DEVELOPMENT APPLICATION ASSESSMENT REPORT

Application Number:	DA2024/0488
----------------------------	-------------

Responsible Officer:	Reeve Cocks
Land to be developed (Address):	Lot 1 DP 124022, 41 Wilson Street FRESHWATER NSW 2096
Proposed Development:	Alterations and additions to a dwelling house including a swimming pool, cabana and front fence
Zoning:	Warringah LEP2011 - Land zoned R2 Low Density Residential
Development Permissible:	Yes
Existing Use Rights:	No
Consent Authority:	Northern Beaches Council
Land and Environment Court Action:	No
Applicant:	Hannah Wright

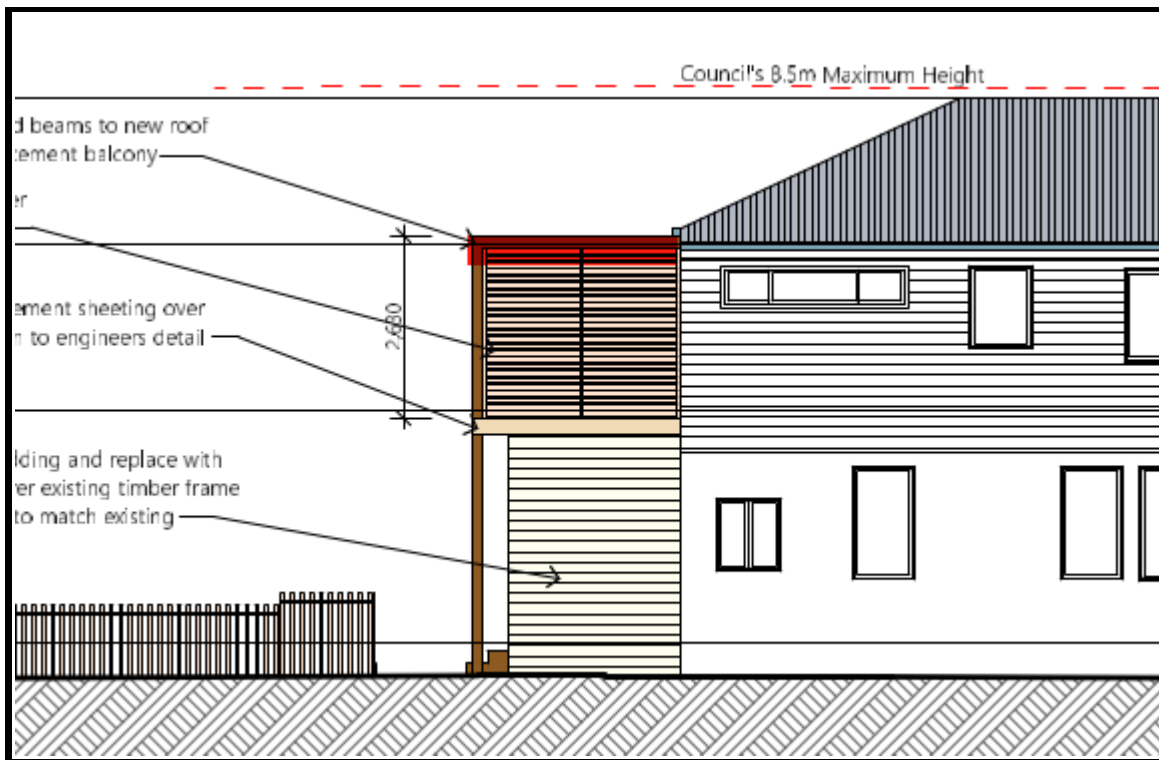
The existing dwelling house has a minor non-compliance on the eastern and western side elevations (see below). The proposed covered balcony is to be built in line with the existing dwelling house and will extend this non-compliance. It should be noted that development is compliant with the side setback, wall height and total building height controls. It is considered that the development meets the objectives of the control without strict compliance.
